UNITED STATES PATENT AND TRADEMARK OFFICE

Office Action Summary	Application No. 10/517,273	Applicant(s) PODIRSKY, BERNHARD	
	Examiner Chi Q. Nguyen	Art Unit 3635

DETAILED ACTION

FIG. 1.

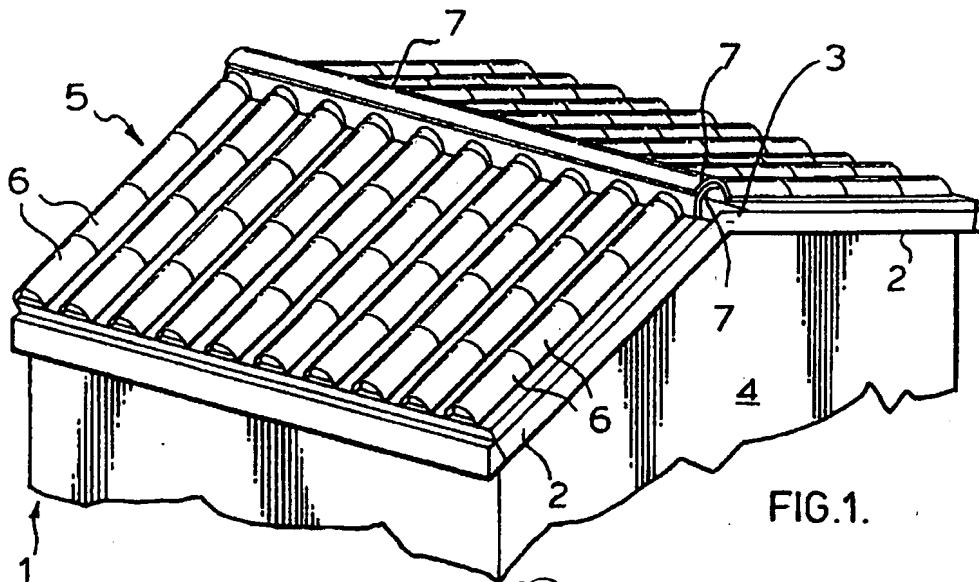
complementary inter-engaging means 18 provided on respective said opposed ends and permitting substantially weatherproof engagement between adjacent body members when laid in longitudinal sequence (see Figs. 1-2).

Wherein the body member portion overlying said roof is adapted to impede the ingress of weather under said body member in use (see Fig. 1).

Wherein mating faces of said overlapping skirt portion and said underlying skirt portion are provided with complementary surfaces features cooperating in use to form a weather impeding labyrinth (see Fig. 1).

FIG. 2.

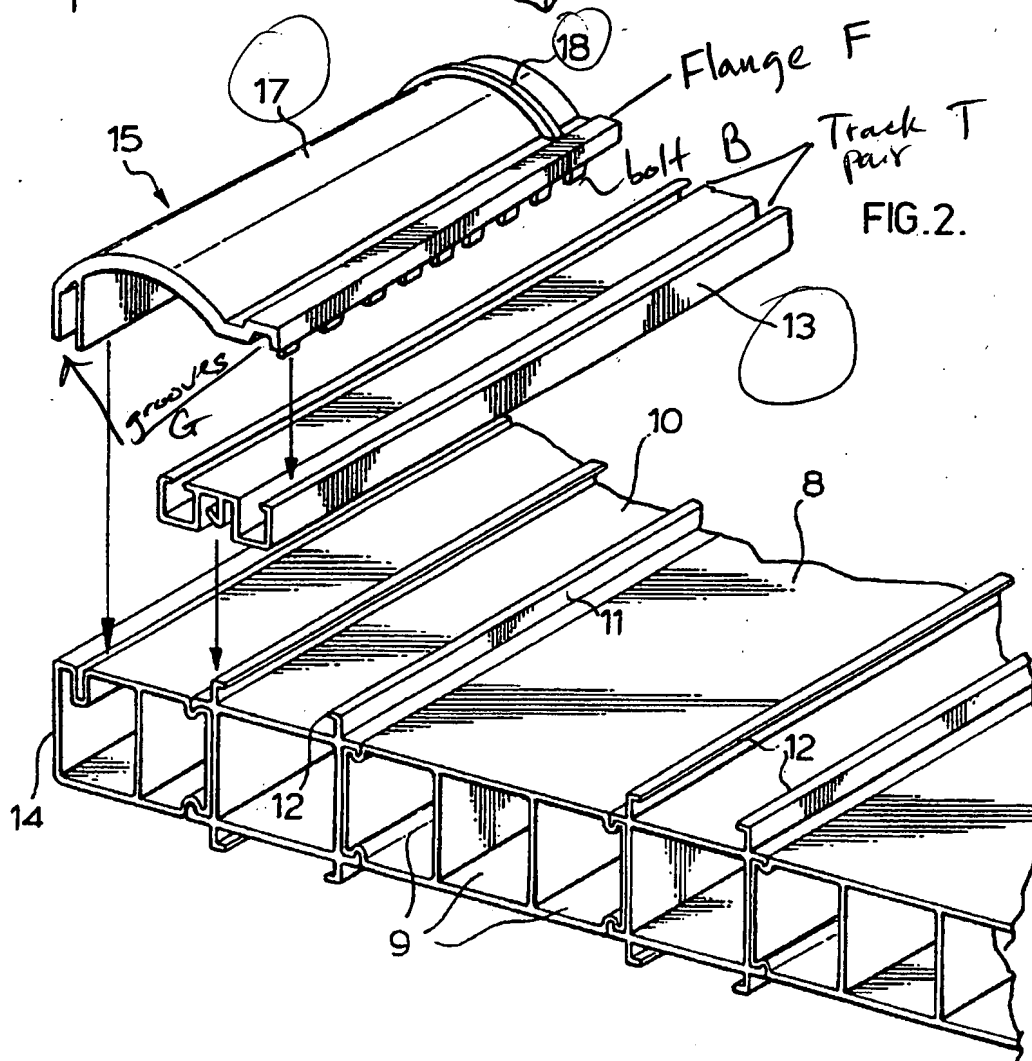
De Zen discloses a cladding apparatus for covering the junction between a roof and a fascia of a building, wherein said apparatus comprises: an elongated body member 15 having an inner surface and an outer surface, each surface extending between opposed ends and opposed elongate side edges of the body member; a mounting batten 13 associated with said fascia 2 and adapted to engage at least one complementary mounting portion provided on said inner surface (no labeled but shown in Fig. 2);

As best understood, De Zen discloses the claimed invention and wherein the adaptation of said body member portion 17 overlying said roof is a flange F (see attachment of Fig. 2) dependent toward said roof from, and extending along, said elongate edge, said roof being provided with an elongate roof batten 14 sealingly supported on said roof, said roof batten including an upper surface against which the inner surface of said body member bears in use (see Fig. 12), one or both of said inner surface and upper surface being provided with one or more elongate grooves forming in use a moisture excluding labyrinth between said inner surface and said upper surface.

Wherein said mounting portion and mounting batten are provided with complementary profiles permitting snap-in connection therebetween (see Fig. 2).

Wherein said mounting portion and mounting batten are provided with complementary profiles permitting connection therebetween by longitudinally sliding said mounting portion on said mounting batten (see Fig. 2).

Wherein said mounting portion and mounting batten are substantially continuous along their respective lengths, whereby said body members are sequentially installed by sliding from one end of said mounting batten (see Fig. 2).

Wherein said mounting portion and mounting batten are complementarily interrupted whereby said body members may be sequentially installed by offering up said body members to said batten intermediate its ends and sliding said body members into engagement with said batten (see Fig. 2).

Wherein said complementary profiles comprise a longitudinal bolt B and track pair T (see attachment of Fig. 2).

Fig. 12), one or both of said inner surface and upper surface being provided with one or more elongate grooves G (see attachment of Fig. 2) forming in use a moisture excluding labyrinth between said inner surface and said upper surface; a mounting batten 13 associated with said fascia and adapted to engage at least one complementary mounting portion provided on said inner surface, said mounting portion and mounting batten being substantially continuous along their respective lengths and provided with complementary profiles permitting connection therebetween by longitudinally sliding said mounting portion on said mounting batten by sliding from one end of said mounting batten (see Fig. 12).
